**Planning Commission
Staff Report**

August 22, 2012
Item 5.a.

SUBJECT: PUD-89

PURPOSE: Application for PUD Development Plan approval to allow the demolition of an approximately 2,950-square-foot building and the construction of an approximately 6,260-square-foot building to provide automotive detailing services, an inventory parking lot, and related site improvements.

FIGURE 4: Proposed Site Plan

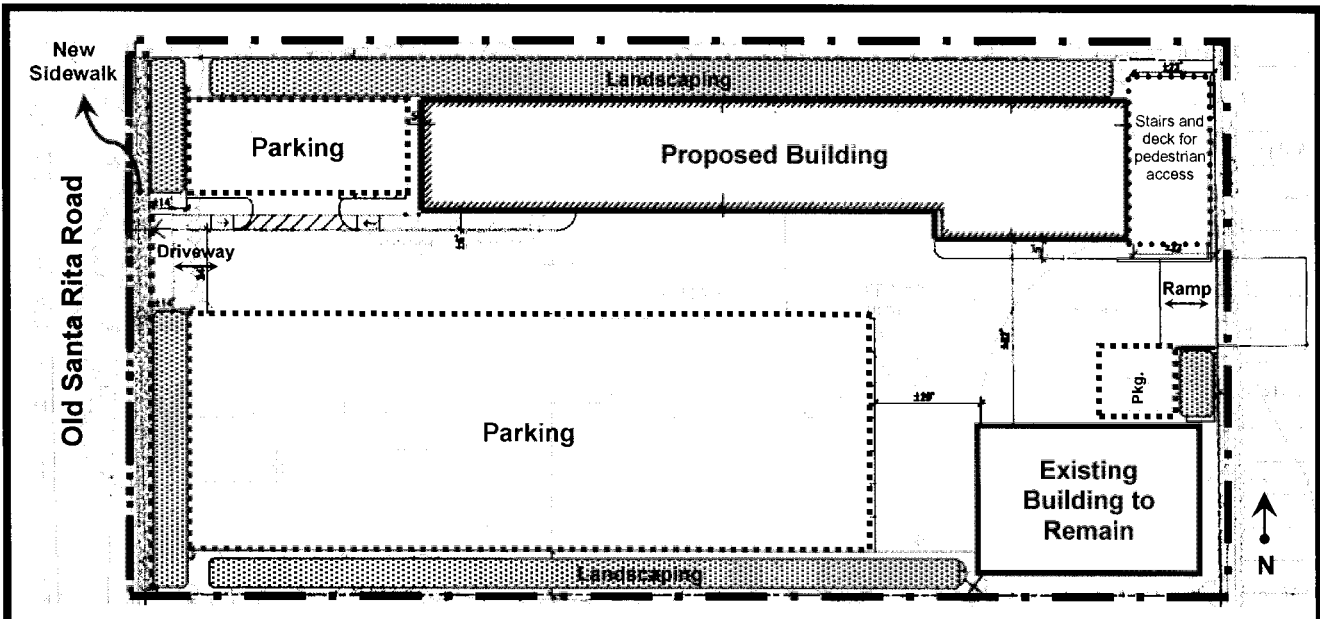
The site plan for the proposed project is provided on Sheets C1 and A-1.0 of the project plans, attached to this report as Exhibit B. The location of the proposed building is similar to where the existing building is located. A new 24-foot wide driveway is proposed from Old Santa Rita Road and provides access to the parking area to the west of the subject building and the “product” parking area near the southern portion of the site. The proposed ramp near the eastern side of the property provides access between the subject site and the East Bay BMW dealership and service facility on the adjoining property at 4350 Rosewood Drive. The California black walnut trees along the front the property will be removed to accommodate construction of a new sidewalk and London plane trees will be planted along the western boundary of the property. Additional landscaping will be provided along the western, northern and southern property lines to provide screening of the site and the building. Overall, staff finds that the site plan is appropriate.

Tree Assessment Map

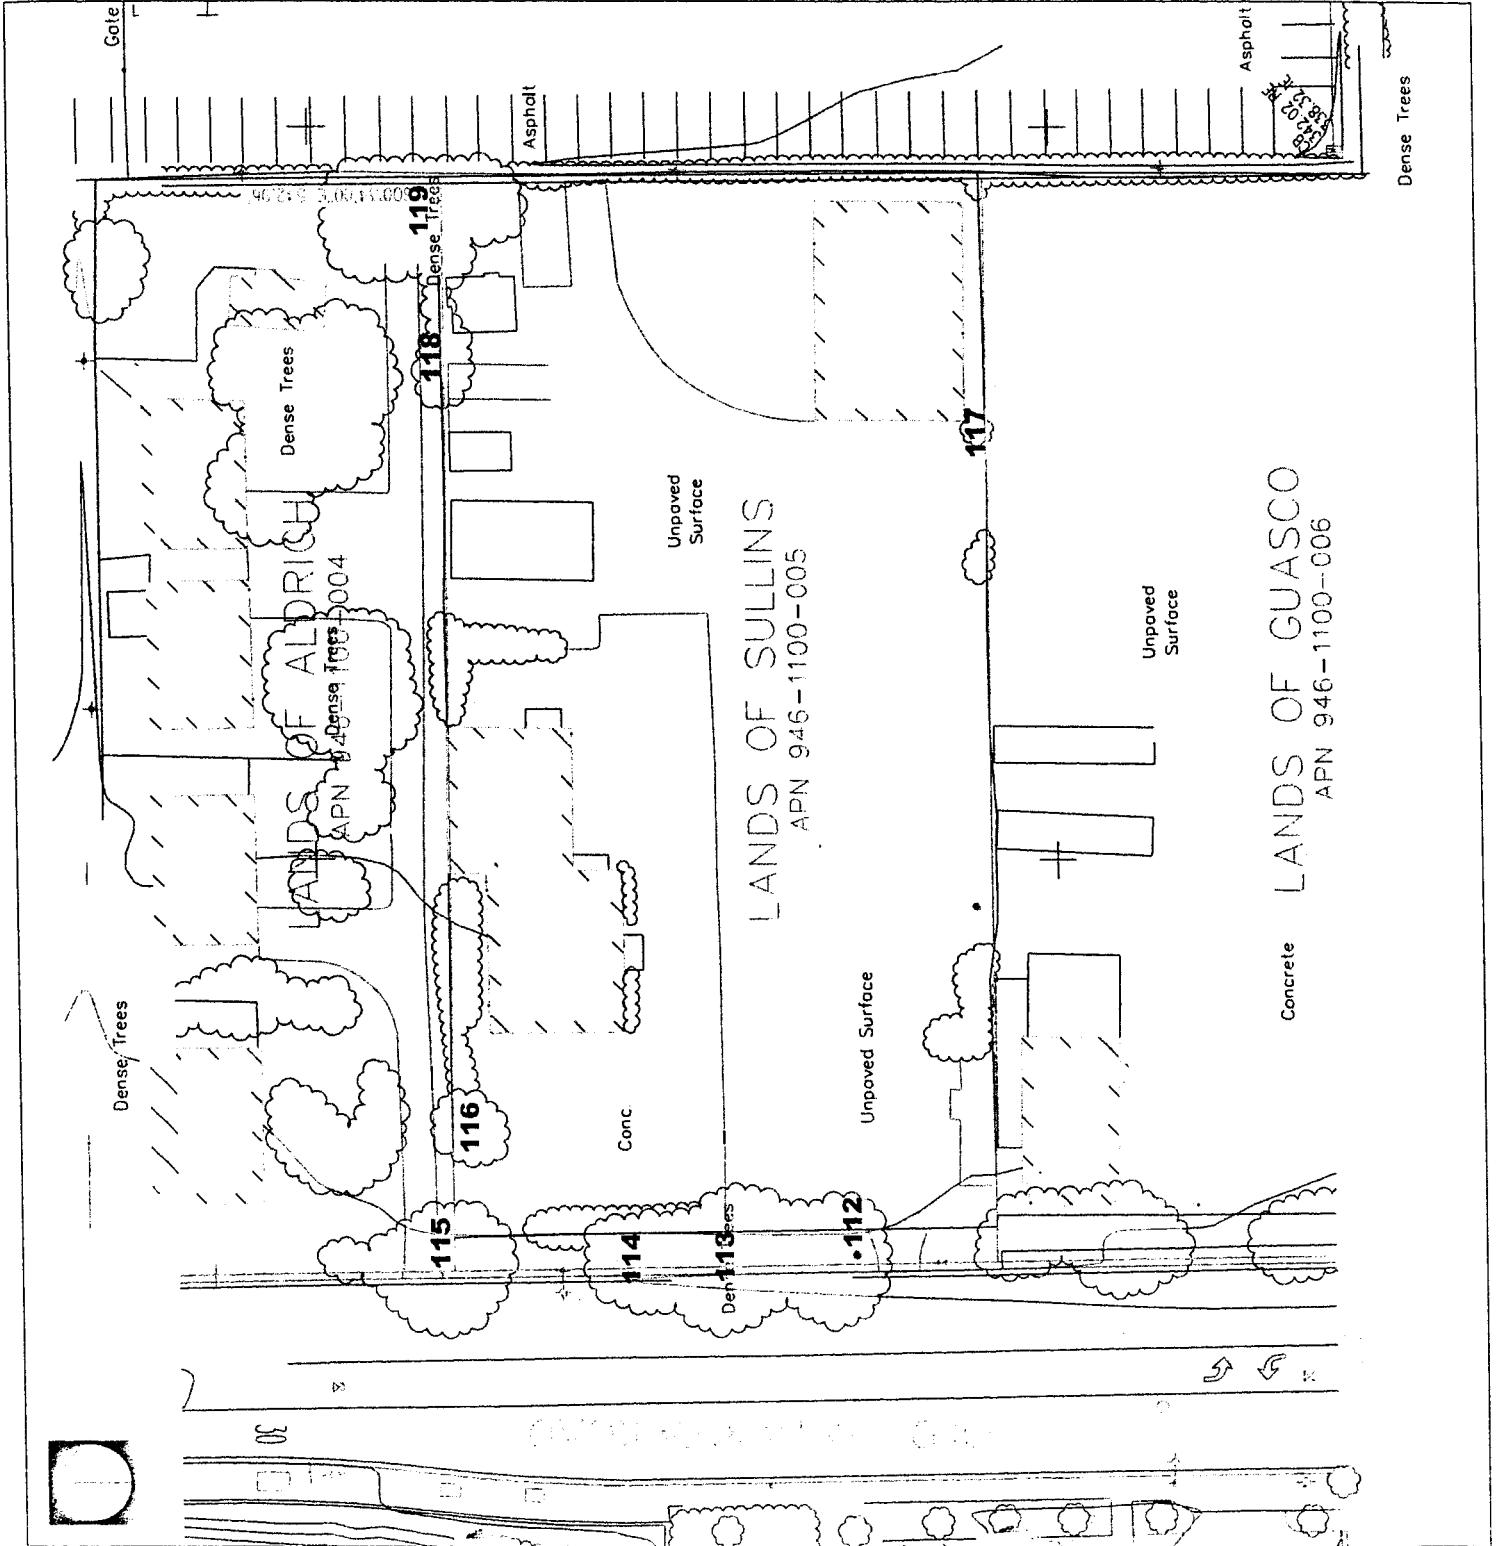
Based on my assessment of the plans, I recommend removal of three (3) trees, including two (2) impacted by the new driveway (#113 and 114), and one (1) due to poor structure (#117).

I recommend preservation for the remaining five (5) trees (#112, 115, 116, 118 and 119), provided recommendations included in the **Tree Preservation Guidelines** (following page) can be followed. Recommended actions for each tree are provided in Table 1, following page.

Tree #116 may require some amount of root pruning once the existing concrete is removed. Off-site trees #118 and 119 will require pruning to provide construction clearance. Pruning of off-site trees must be done with the property owner's permission.
